AGENDA
HISTORIC PRESERVATION / DESIGN REVIEW COMMISSION

November 2, 2016 – 4:00 PM

Administrative Staff Report

Install Mechanical Equipment
 Design Review Request
 1519 Water Street
 October 21, 2016

ROOFS (Sec. 3.5)

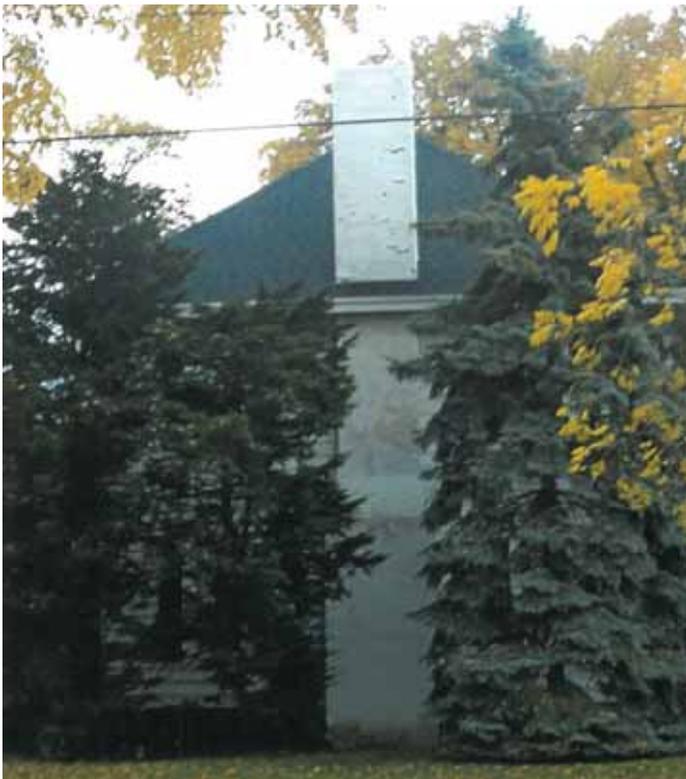
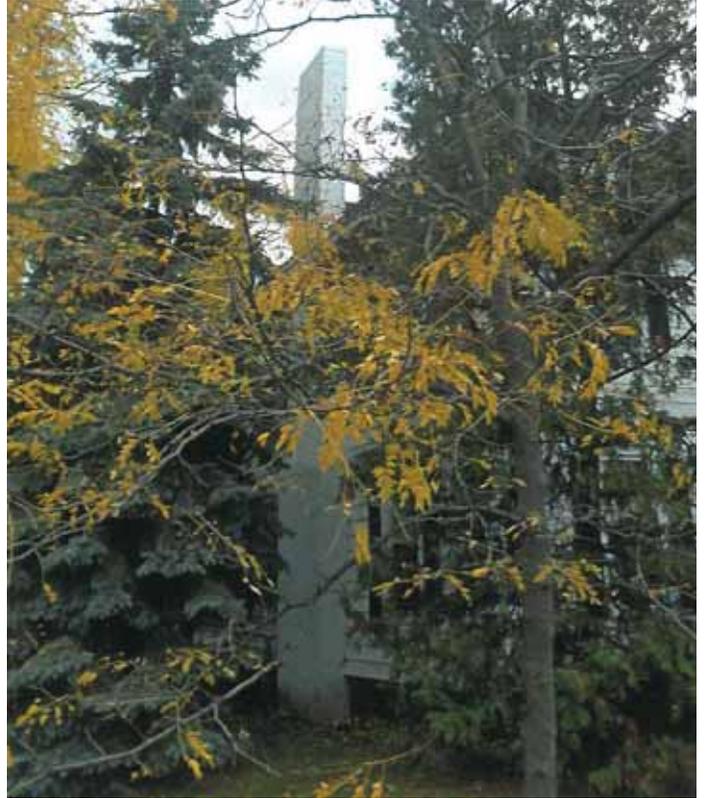
2. Character-defining elements of historic roofs should be retained and preserved including dormer windows, chimneys, turrets, cupolas, and parapet walls. Eave overhangs, moldings and trim, and soffit board should also be retained and preserved.

Analysis: As indicated above, staff has identified the chimney as a character-defining element, given its exposure on the western façade and large size.

In conclusion and based on the findings above, staff recommends denying the design review request to remove a portion of the chimney above the roof. Staff would instead recommend approving the reconstruction of the chimney above the roof.

Building Images

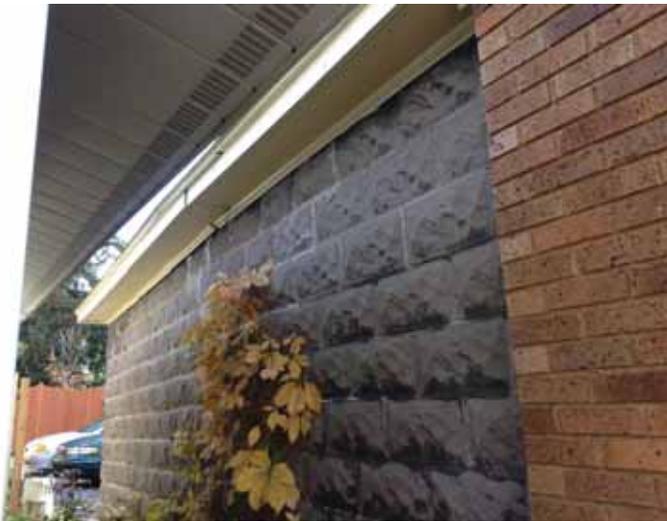
Findings: Given the garage construction date similar to the home and complimenting the design of the home, the detached garage likely contributes to historic character of the home. Although brick matches the home, the design of the garage is simple. Windows exist on the garage along with a service door which add characteristics to the garage, but are not necessarily defining features.
